Technical Note

201-27 (202, 203, 204)  
205-17, 206-14  
301-34, 303-15, 304-5  
401-21, Falcon Nr.2

Subject: Elevator actuating bracket

201-33-4

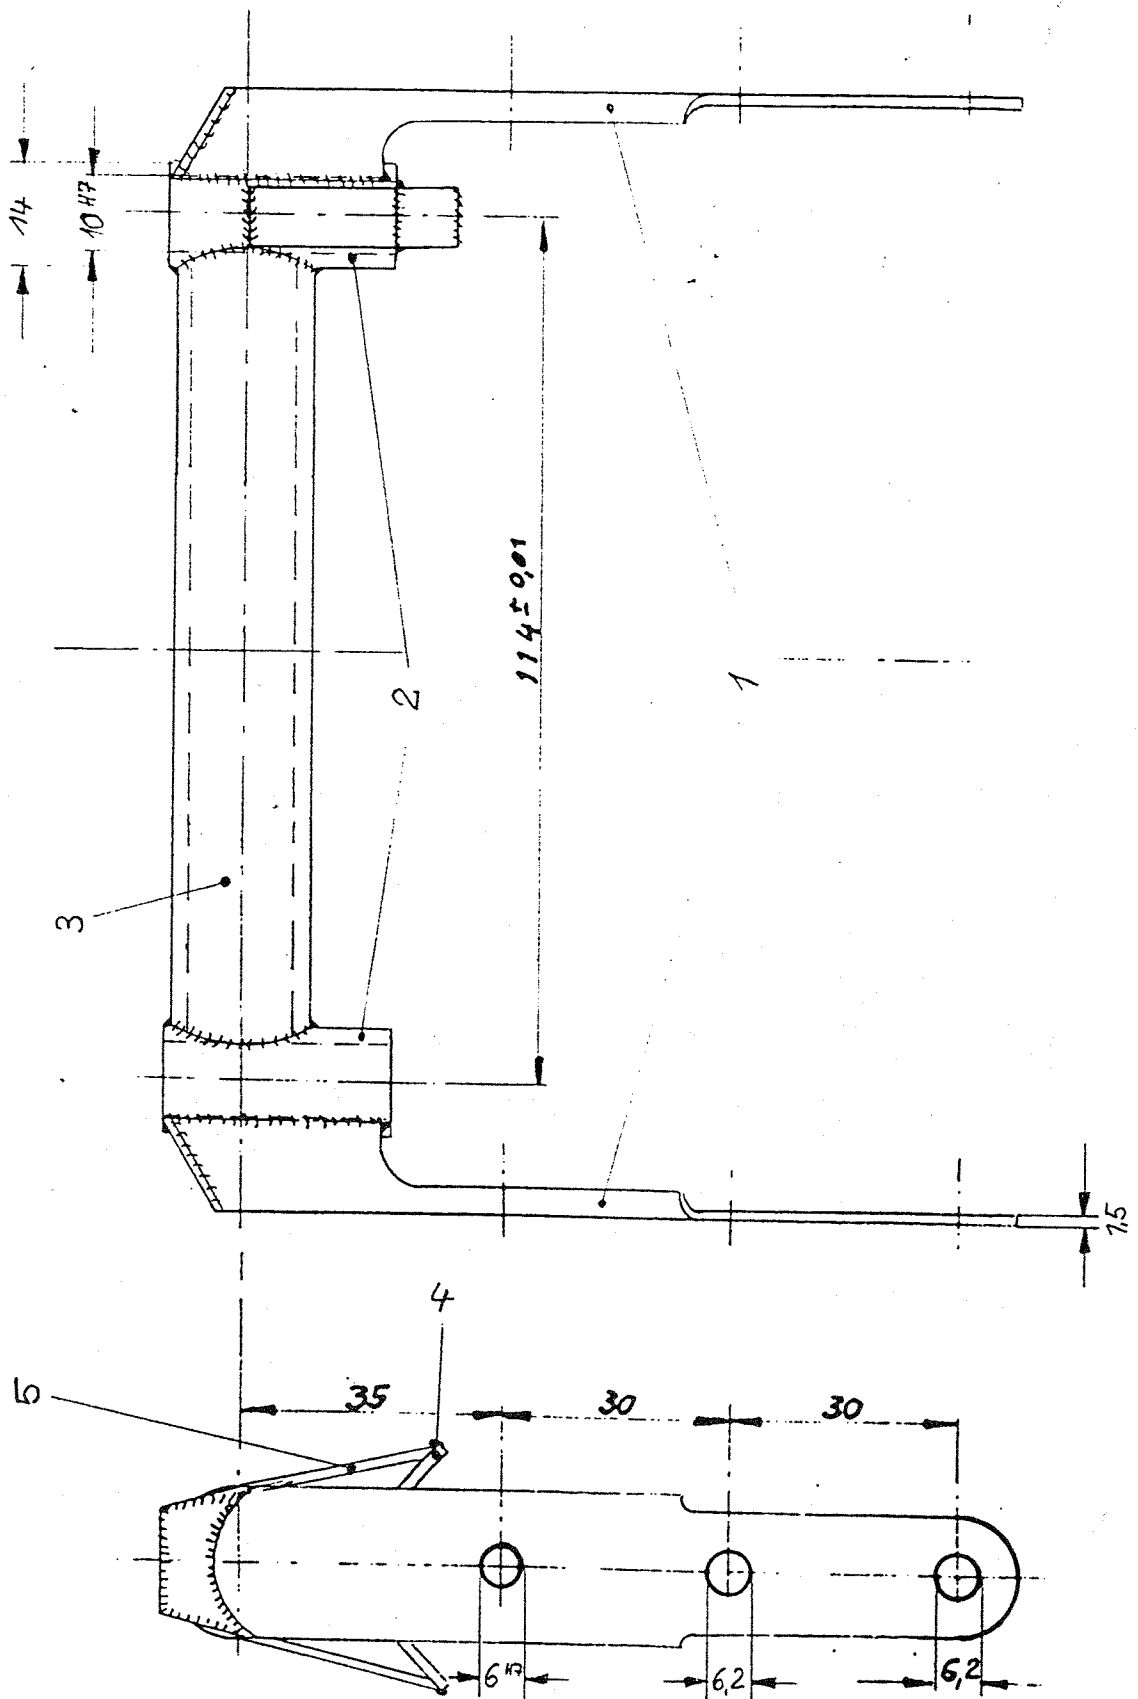
Reason: Use of a bracket as per drawing no. 201-33-4 instead of former bracket types permissible.

Actions: In case of elevator actuating exchange use following procedure:  
Unscrew the 6 screws on the elevator actuating bracket. Pay attention to the type and number  
of washers at each bolt. Mark position precisely!  
Install new actuating bracket including the washers on the same position.  
Tighten screws carefully and check free motion of the elevator.

Material: Elevator actuating bracket according to drawing no. 201-33-4 is available from
